Department of Transportation

MEMORANDUM

SUBJECT: ZC Case No. 23-29 – 4339-4363 Martin Luther King Jr. Avenue and 201-211 Elmira Street SW (Martins View)

Figure 1 | Site Plan

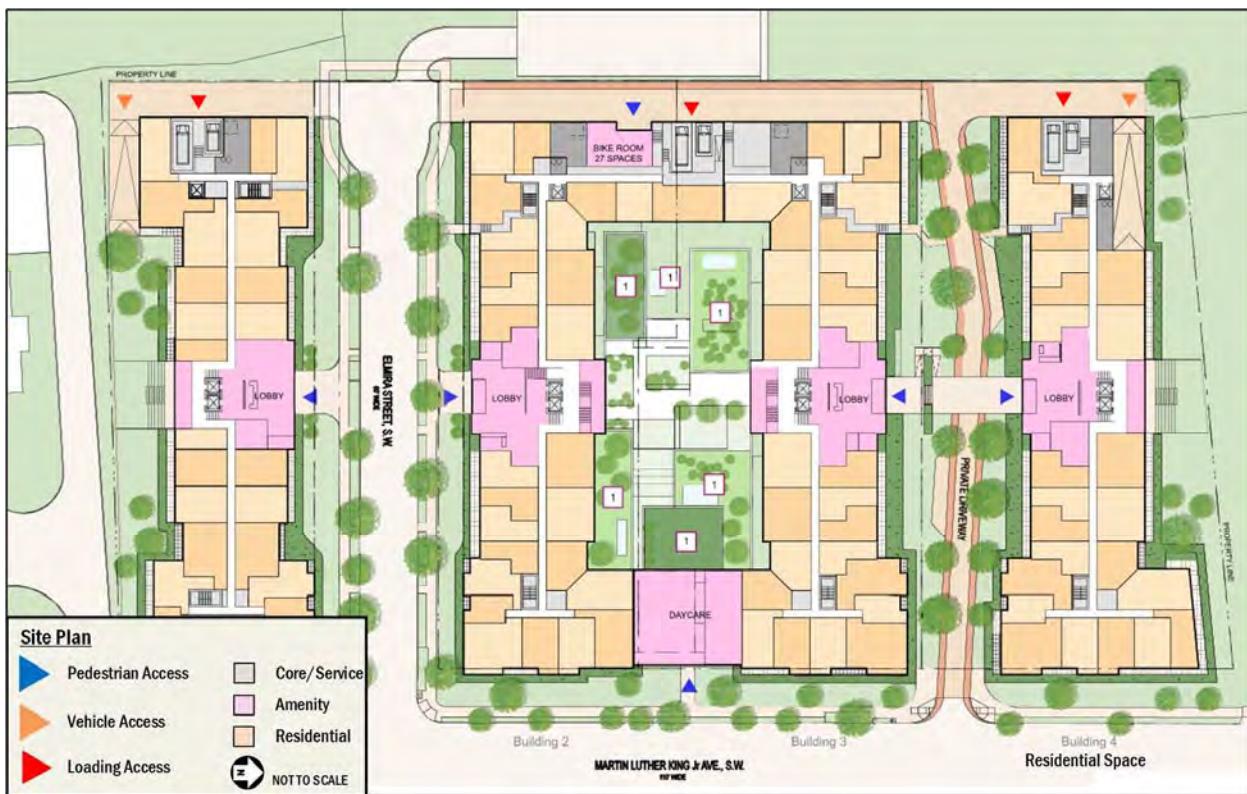
While the preliminary public space plans, shown above in Figure 1, are generally consistent with DDOT standards, there are several considerations that need to be reviewed in greater detail during the public space permitting process:

- All vehicular site access to the site, as well as loading facilities and trash pick-up, must be from the proposed private driveway network via Elmira Street SW;
- Close the three (3) existing curb cuts on Martin Luther King Jr. Avenue SW and restore the former driveways to green space. No new curb cuts beyond the proposed curb cuts to accommodate the private driveway network (one on Martin Luther King Jr. Avenue and two on Elmira Street) will be approved;

- The Applicant should extend the park-like plaza along the one-way, eastbound private driveway around the southeast corner of Building 4 to the public parking area behind the existing southbound bus stop at Darrington Street SW. This area should include seating and a bus shelter or other protection from the elements;

- As discussed in detail in the *Curbside Management* section, TESD's Traffic Safety Branch (TSB) has identified significant safety concerns with the proposed location of the daycare at the center of Building 2/3 along Martin Luther King Jr. Avenue. The Applicant will need to fund and construct pedestrian safety treatments along Martin Luther King Jr. Avenue, subject to DDOT approval, as described in the *Recommendation* section;

Figure 5 | Proposed Curbside Designations

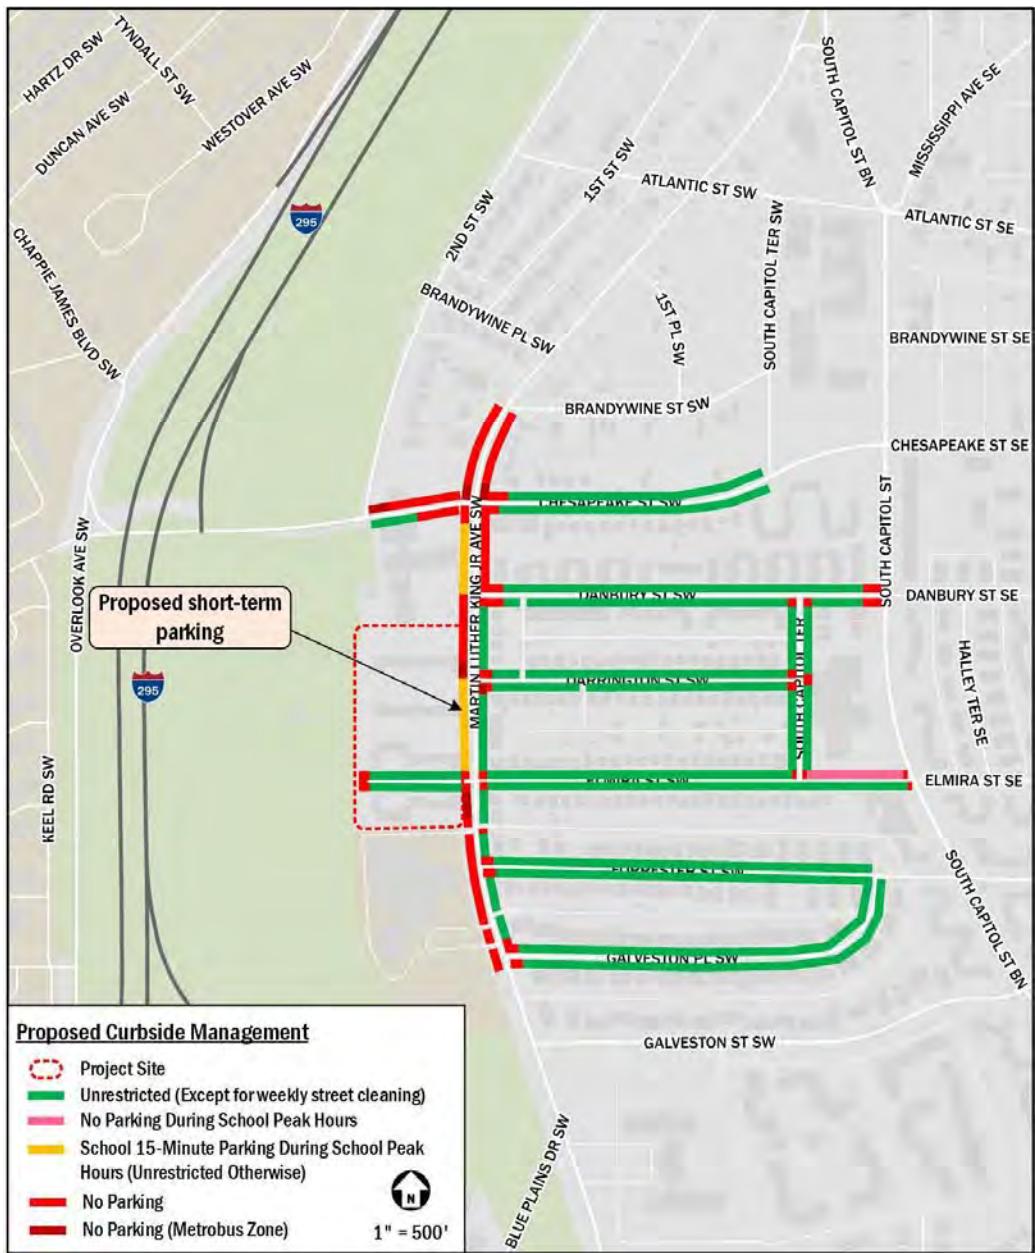
The site currently has mostly unrestricted (except for weekly street cleaning) along both Martin Luther King Jr. Avenue and Elmira Street frontages. Short segments of No Parking and No Parking (Metrobus Zone) are also present. As shown below in Figure 5, the Applicant is requesting short-term, 15-minute

A detailed curbside and signage plan must be submitted during public space permitting for review and approval by CMD, TSB, and PSD's Safe Routes to School (SRTS) team. At that time, the plan may be refined, and the exact signage placards will be determined. If multi-space meters are required by CMD then they will be at the Applicant's expense.
